# Pennsylvania Power & Light Company

SUSQUEHANNA STEAM ELECTRIC STATION  
CHUGGING LOAD DEFINITION  
ER 100450 FILE 172-08  
PLA-1097

RESPONSE TO NRC CONCERNS REGARDING THE SSES  
CHUGGING LOAD SPECIFICATION

Figure 1-9

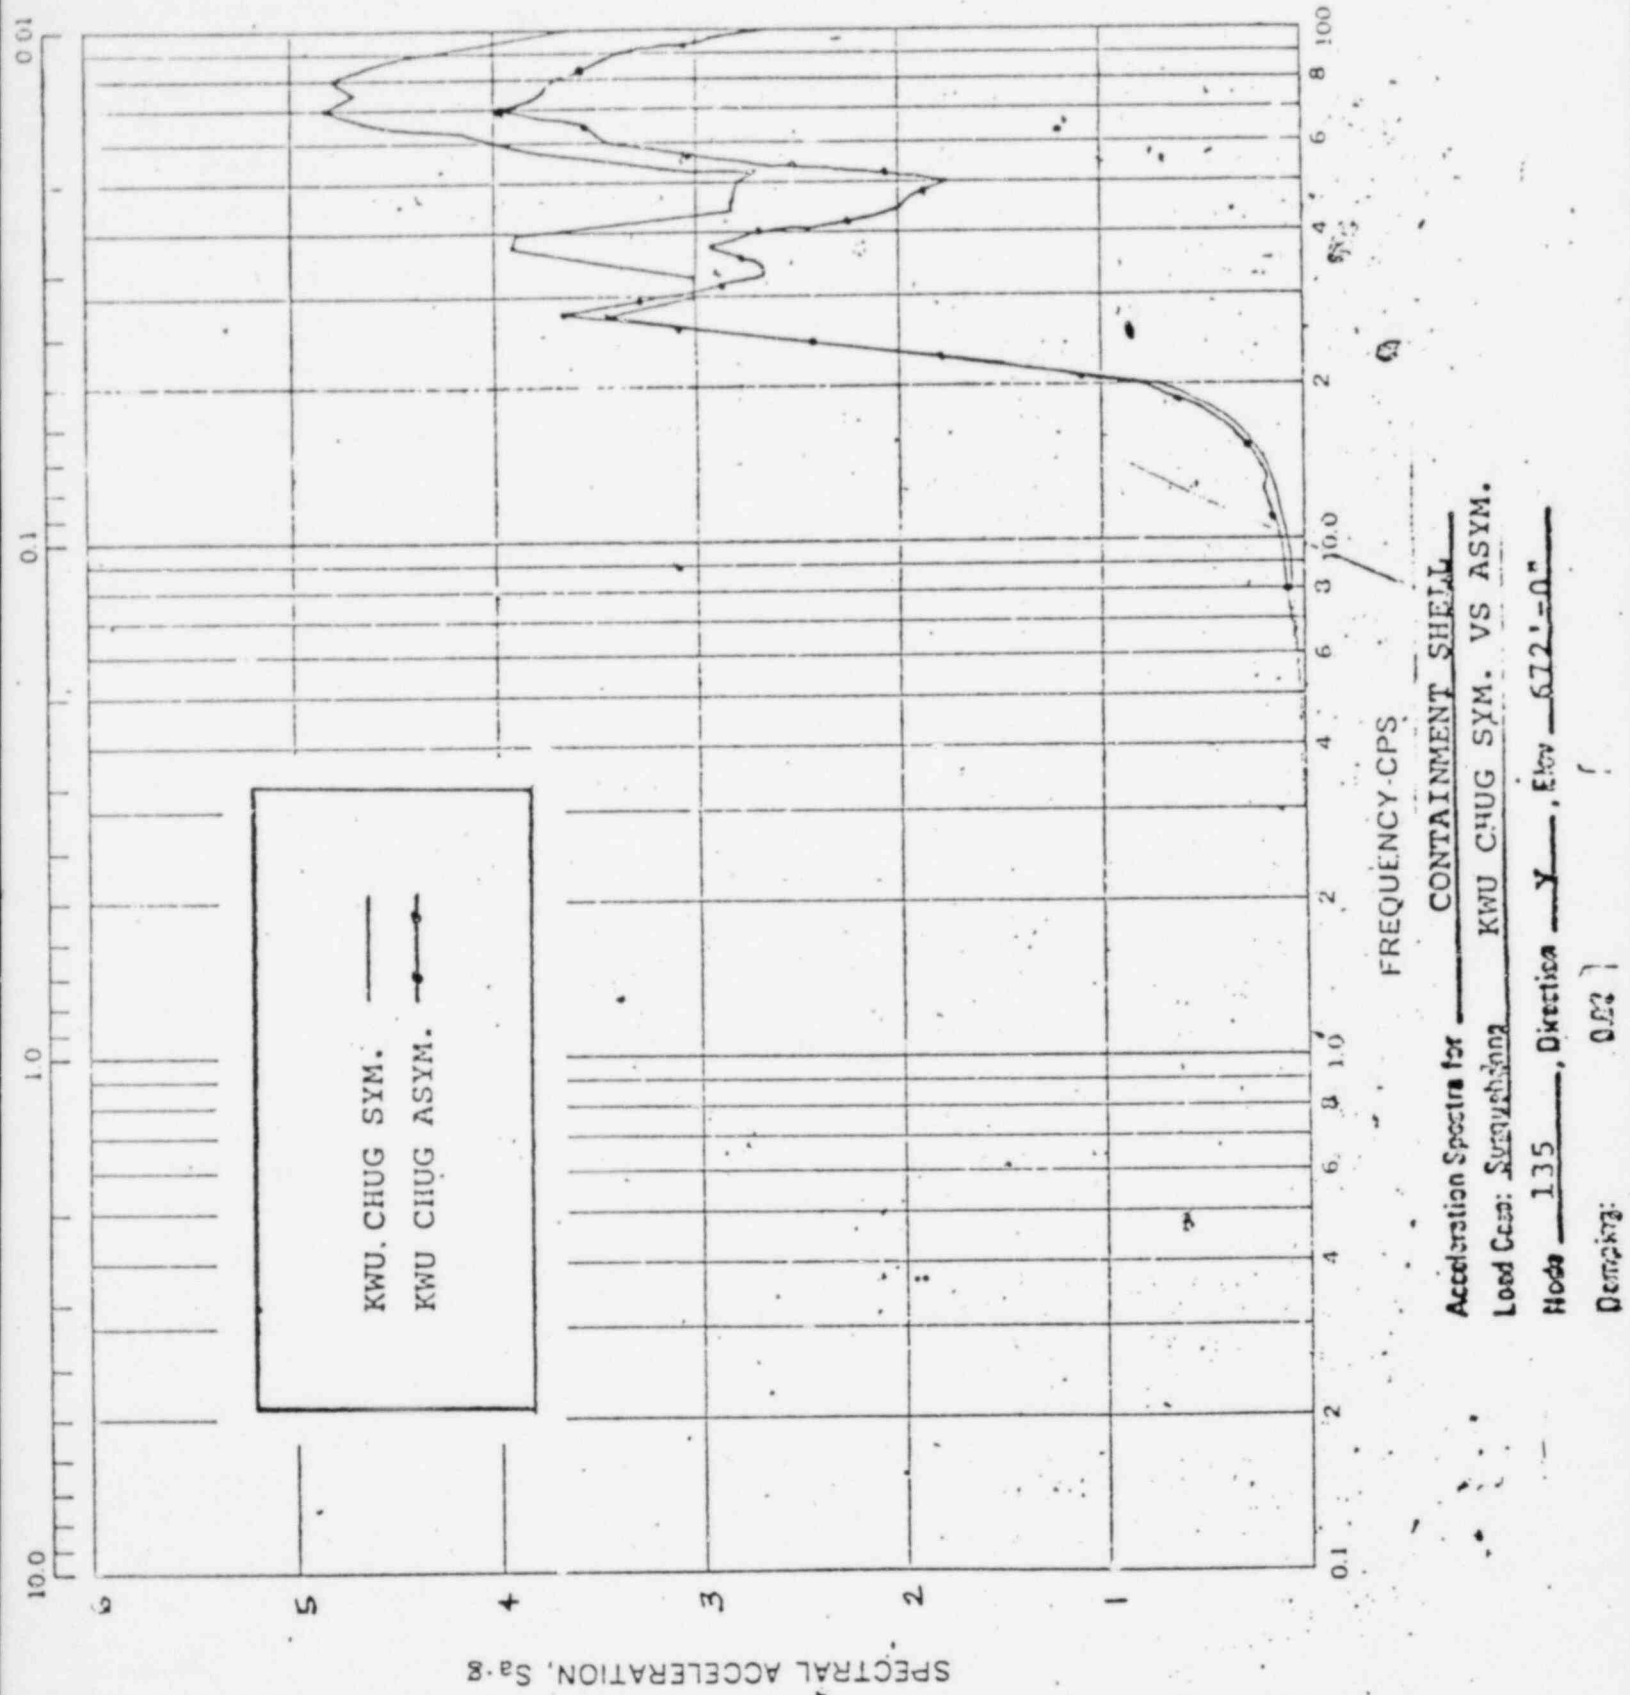
- o Figure 1-9: This figure indicates that above 30 Hz the symmetric response exceeds the asymmetric response by a large margin. At this containment azimuth location, we determined that the Mean Square Power (MSP) for the pressure at the intersection of the containment wall and basemat, varies for the symmetric and asymmetric load case. Our analysis indicated that the symmetric MSP exceeds the asymmetric MSP at this azimuth location; probably due to the effects of the chug start times for downcomers in close proximity to this azimuth angle. Because of this, one would expect the symmetric case to exceed the asymmetric case.

Figure 1-10.

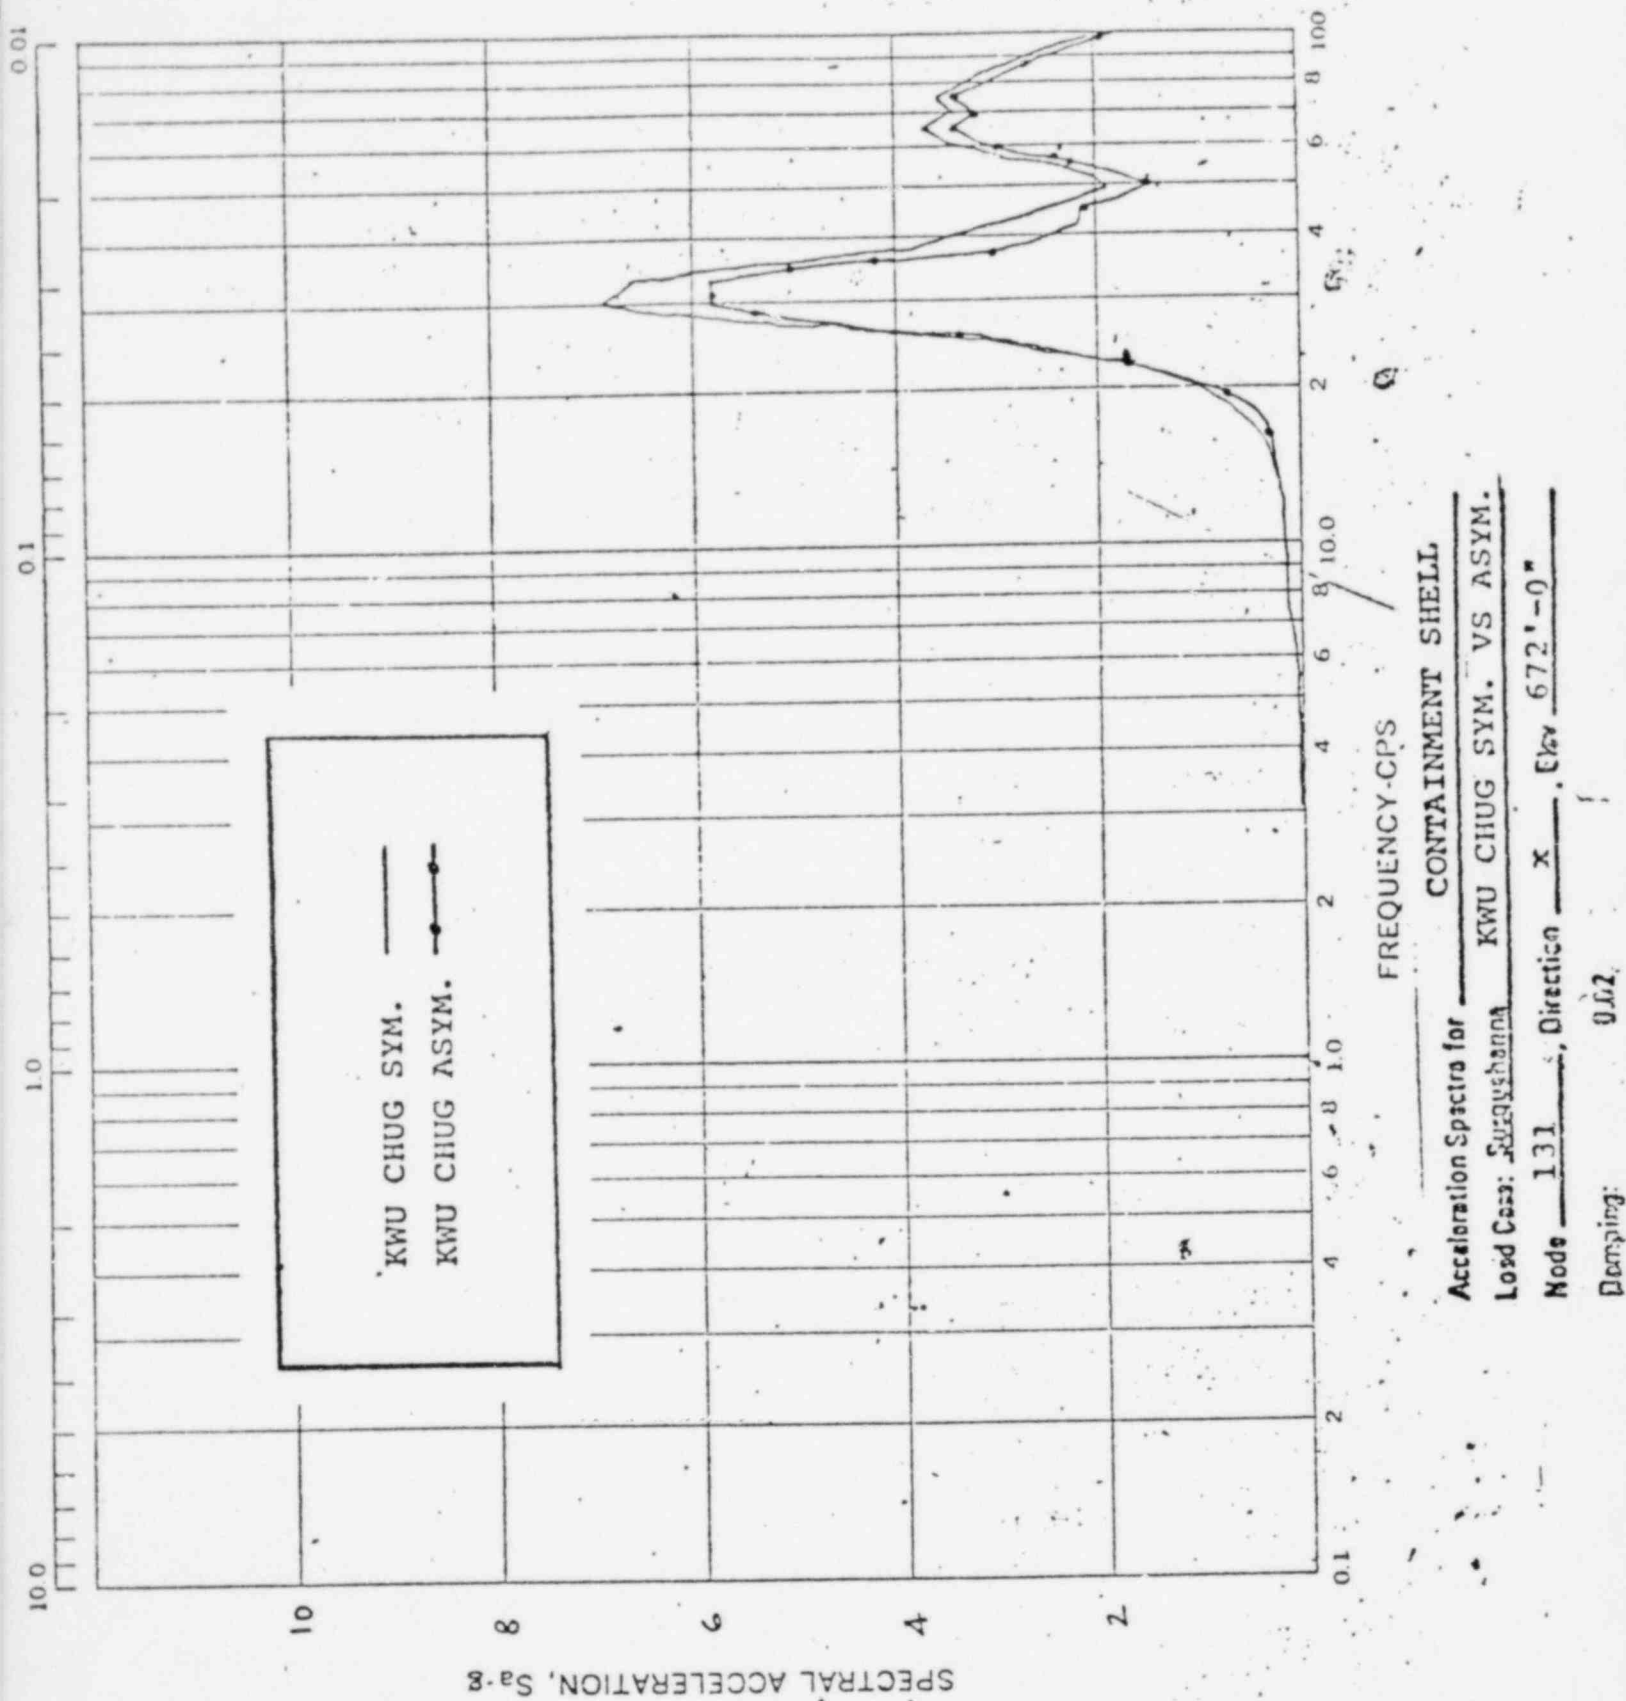
- o Figure 1-10: For all frequencies, the symmetric and asymmetric load cases exhibit a similar response.

Figure 2-1. COMPARISON OF FLEXIBLE WALL SONIC SPEEDS  
IN GKM II-M AND JAERI TEST FACILITIES.

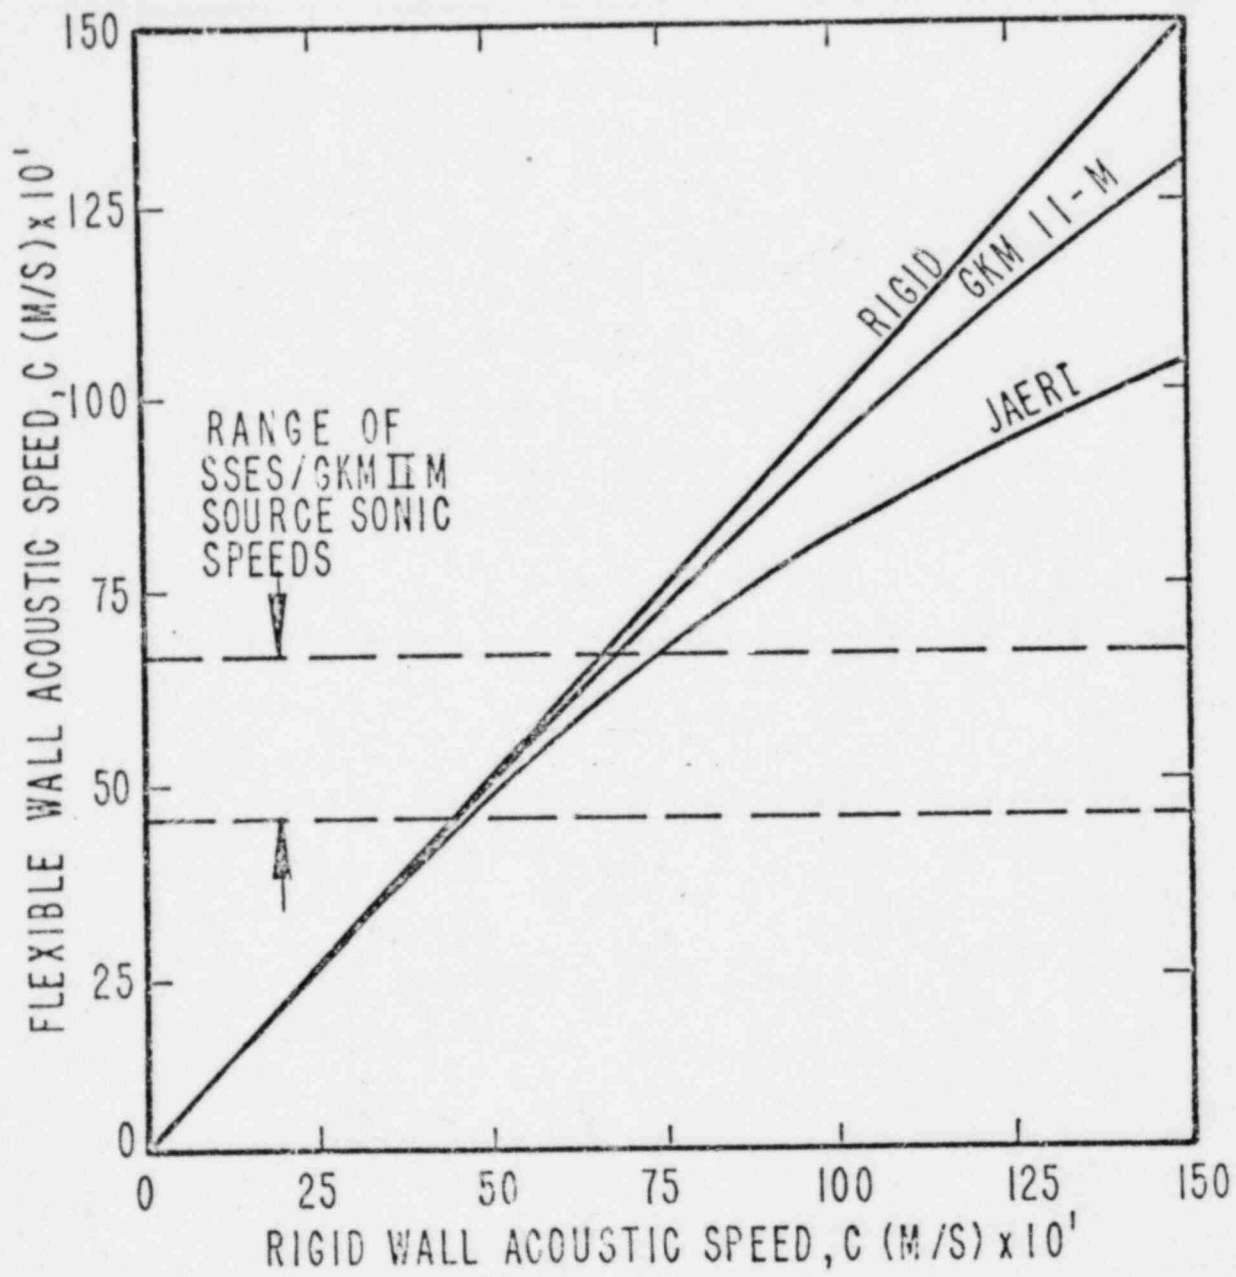
where  $\rho$  is the water density,  $C$  is the flexible wall sonic speed,  $C_0$  is the rigid wall sonic speed and  $\delta$  is volume distensibility\*. Figure 2-1 shows the relationships between the rigid wall sonic speeds and flexible wall sonic speeds for GKM II-M and JAERI facilities.

Ideally, the GKM II-M "rigid wall" sonic speeds would be obtained first by using the above relation. The rigid wall sonic speeds would then be corrected to obtain the equivalent flexible wall sonic speeds for JAERI. These corrected sonic speeds would then be used with the corresponding sources in the JAERI acoustic model for predicting the JAERI wall pressures. However, this procedure was not used because the differences between the GKM II-M flexible wall sonic speeds and the corresponding JAERI flexible wall sonic speeds is less than 7% over the range of sonic speeds (661 m/sec to 449 m/sec) for the SSES/GKM II-M sources.\*\* This small difference did not warrant the added computational complexity and hence the GKM II-M sonic speeds were used in the JAERI wall pressure computations.

Figure 2-2 COMPARISON OF THE MINIMUM PSD ENVELOPE OF  
20 MIN. VAR. STS TRIALS WITH MAXIMUM PSD  
ENVELOPE OF JAERI DATA AT 1.8M ELEVATION--  
AMPLITUDE FACTOR 1.3.

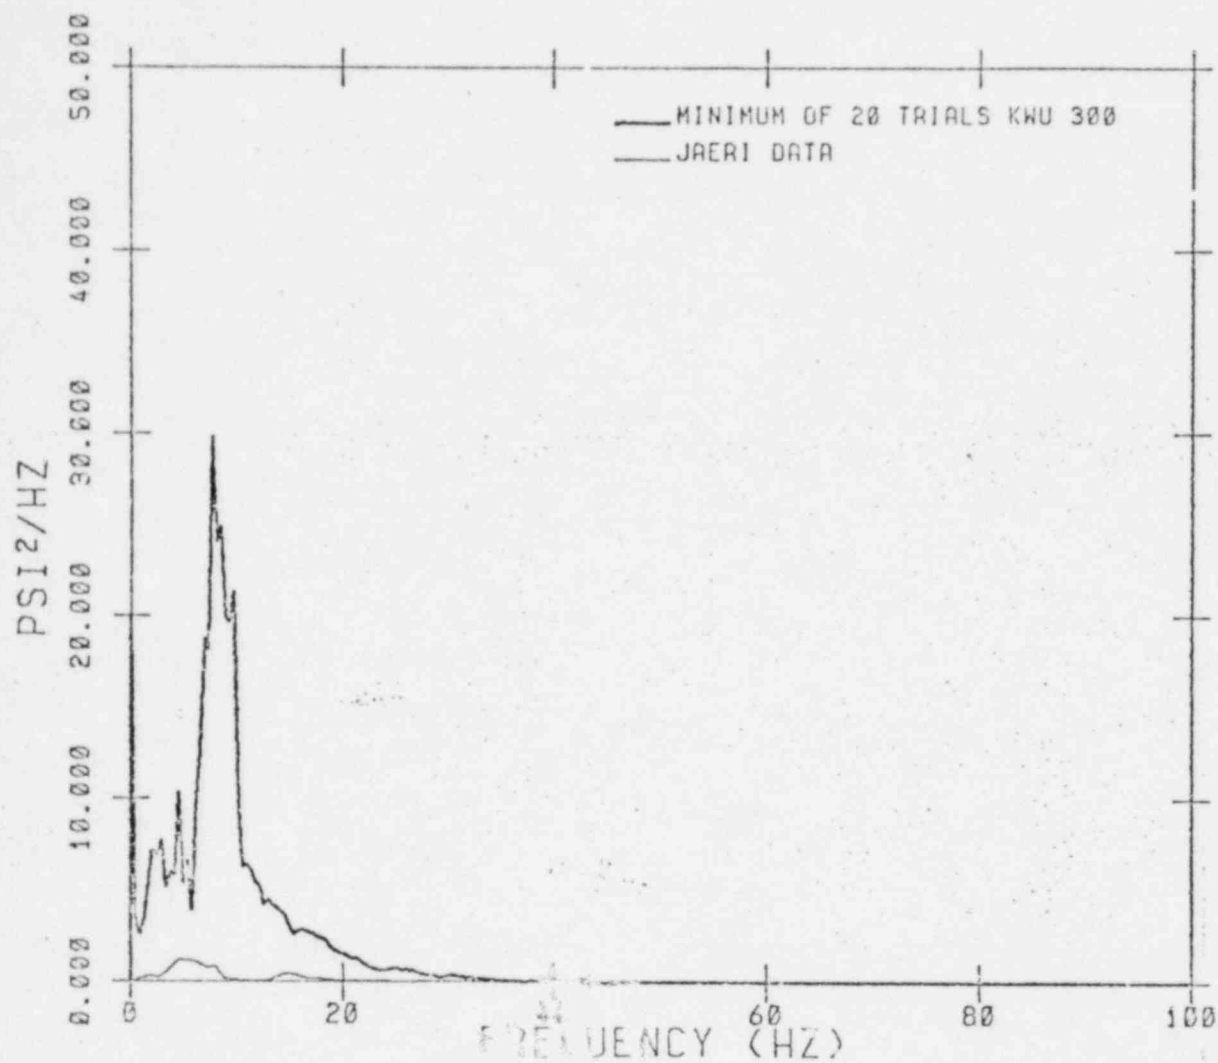
Figure 2-2 shows the comparison of the minimum envelope of 20 minimum variance STSs with the JAERI data at the 1.8 meter elevation. The amplitude factor used here was that for the SSES containment and equal to 1.3. From this figure it is seen that the minimum envelope of the 20 minimum variance STSs bounds the JAERI data by a substantial margin at frequencies below about 40 Hz. Above 40 Hz, the signal levels are quite small and so from this linear plot it is difficult to make many comparisons. Therefore, the same data plotted on log scale are shown in Figure 2-3. From this figure it is seen that the minimum envelope drops below the maximum JAERI data envelope by a small amount in the frequency range between 40 and 80 Hz.

Figure 2-4. COMPARISON OF THE MINIMUM PSD ENVELOPE OF  
20 MIN. VAR. STS TRIALS WITH MAXIMUM PSD  
ENVELOPE OF JAERI DATA AT 3.6 M ELEVATION--  
AMPLITUDE FACTOR 1.3.

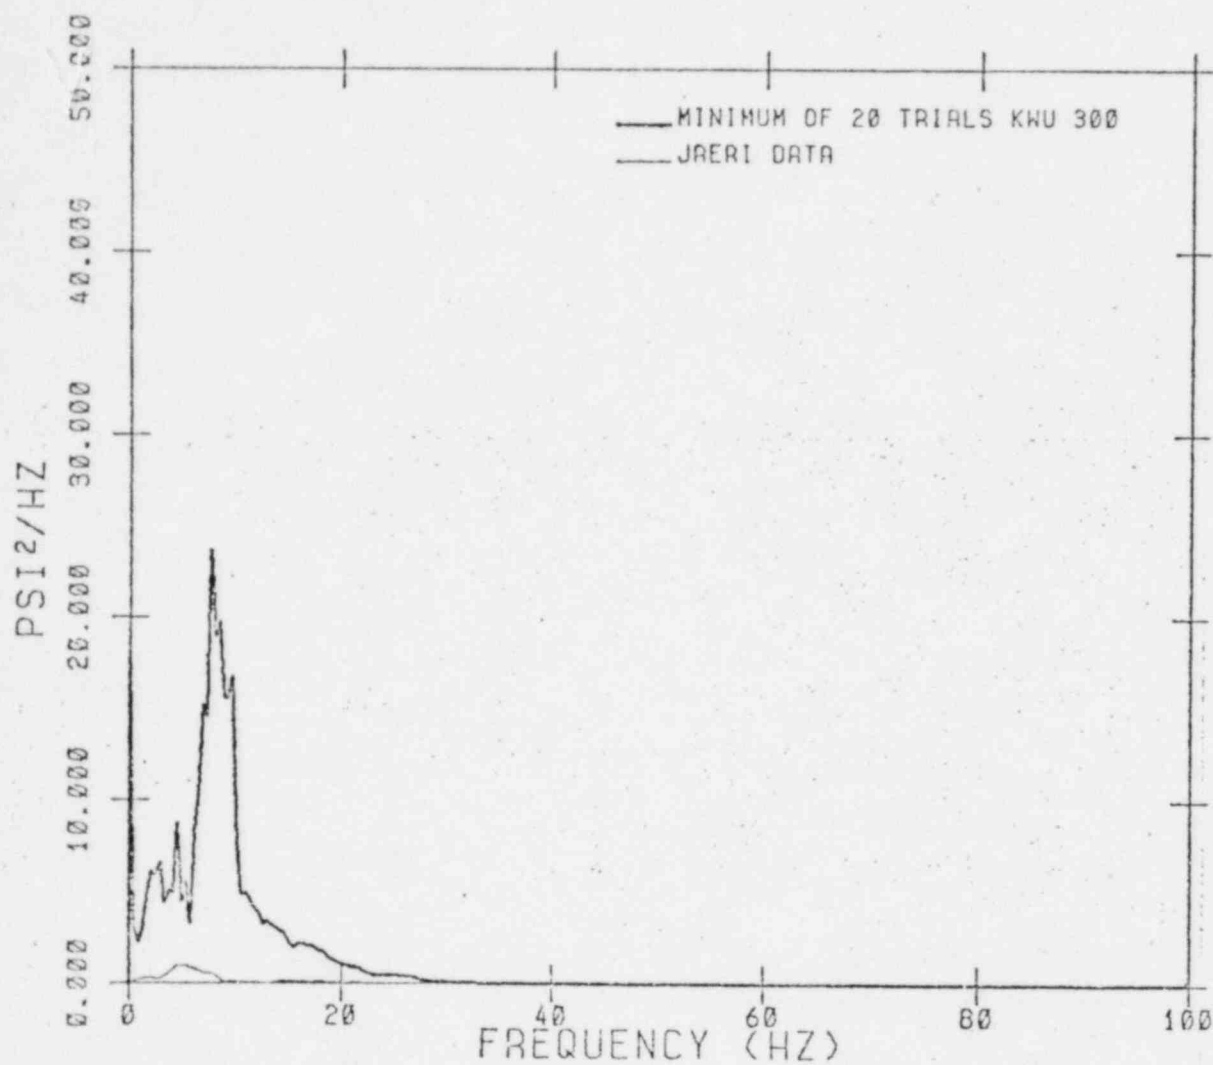
Figure 2-4 shows the comparison of the minimum envelope of 20 minimum variance STSs with the maximum JAERI data envelope at the 3.6 meter elevation. From this linear plot, it is again seen that the minimum envelope of the 20 minimum variance STSs bounds the JAERI data envelope by substantial margins and both the JAERI data envelope as well as the 20 minimum variance STSs en-
